SUBJECT: MEETING NOTIFICATION AND TRANSMITTAL OF AGENDA

MEETING MINUTES FROM THE
MARICOPA ASSOCIATION OF GOVERNMENTS
STANDARD SPECIFICATIONS AND DETAILS COMMITTEE

Case # 08-10

RE: **Modifications Detail 200, Section 336 & Section 601: Trench Backfill and Pavement Replacement**

DETAIL NO.
200-1

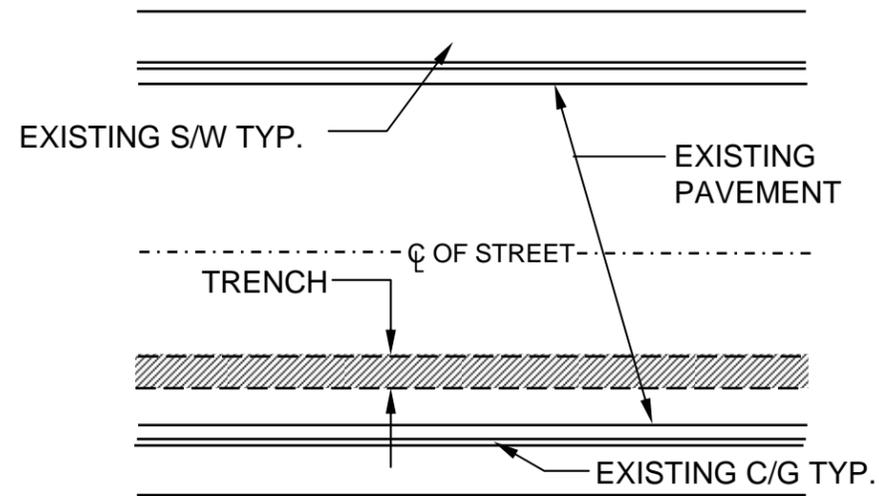
The attached details and specification section revisions have been modified per comments received from Maricopa County and City of Tempe.

Maricopa County also recommends reducing the depth of base ABC under pavement in Type "A" longitudinal trench repair from 24 inches to 12 inches (or match existing, whichever is greater) to make this detail more compatible with Type "B" requirements. Please provide feedback on this concept in your subsequent comments.

- NOTES:
1. PAVEMENT MATCHING AND SURFACE REPLACEMENT SHALL BE IN ACCORDANCE WITH SECTION 336.
 2. TYPE OF BACKFILL AND BASE (IF APPLICABLE) SHALL BE AT CONTRACTOR'S OPTION UNLESS OTHERWISE SPECIFIED IN CONTRACT DOCUMENTS.

3. TRENCHES LESS THAN 24" WIDE SHALL BE BACKFILLED FROM TOP OF BEDDING TO BOTTOM SURFACING MATERIALS WITH 1-SACK CLSM PER SECTIONS 604 AND 728.
 4. BASE, BACKFILL, BEDDING AND FOUNDATION COMPACTION REQUIREMENTS SHALL BE IN ACCORDANCE WITH SECTION 601.

5. ASPHALT CONCRETE BASE AND SURFACE COURSE SHALL COMPLY WITH SECTION 336.2.4.1.
 6. PROVIDE 12" MINIMUM BASE WIDENED AS SHOWN IN TRANSVERSE TRENCH (TYPE B) AT ENDS OF LONGITUDINAL TRENCH (TYPE A), EXCEPT WHERE EDGE ABUTS EXISTING CONCRETE.

7. USE TRANSVERSE TRENCH (TYPE B) SURFACE REPLACEMENT WHERE A LONGITUDINAL TRENCH (TYPE A) CROSSES A STREET OR GOES THROUGH AN INTERSECTION.
 8. COPPER OR POLYETHYLENE WATER PIPES EXPOSED IN TRENCHES TO BE BACKFILLED WITH CLSM SHALL BE WRAPPED WITH MIN 3/4" THICK CLOSED CELL FOAM INSULATION OR 3/4" WIDE BLACK INSULATION BEFORE PLACING CLSM.
